Addendum No. 1

Re: **Parking Lot Renovations – Riverside High**

IFB No.: **324-99-5-13**

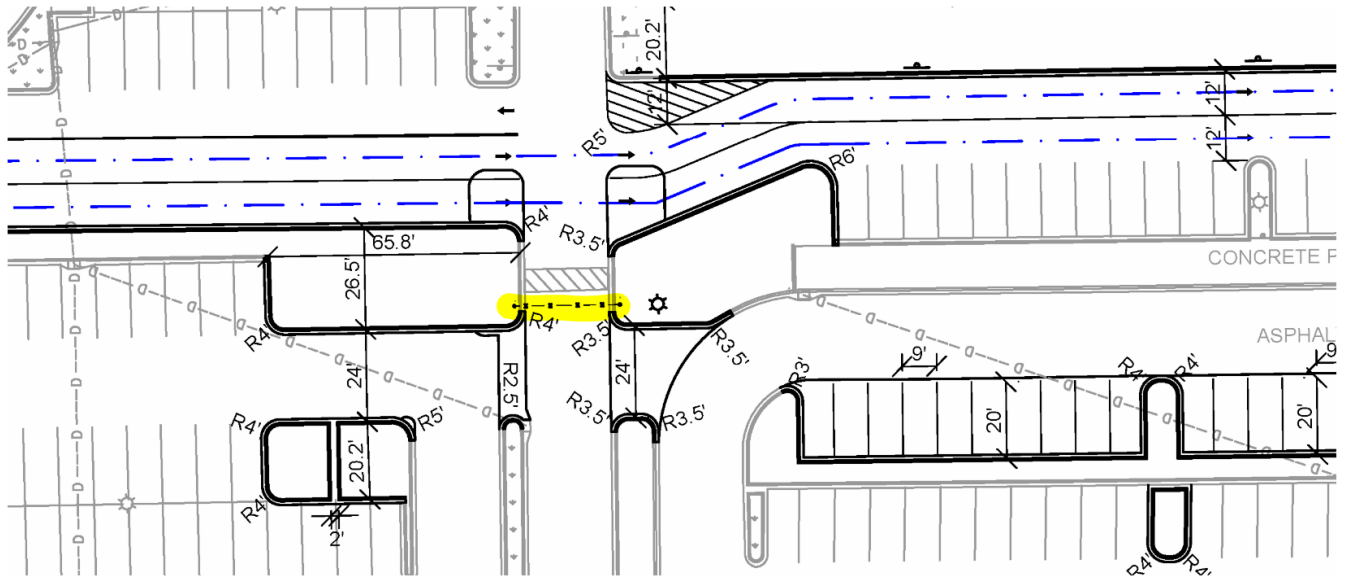
4.) I highlighted a crossing below, can you tell me what that is?
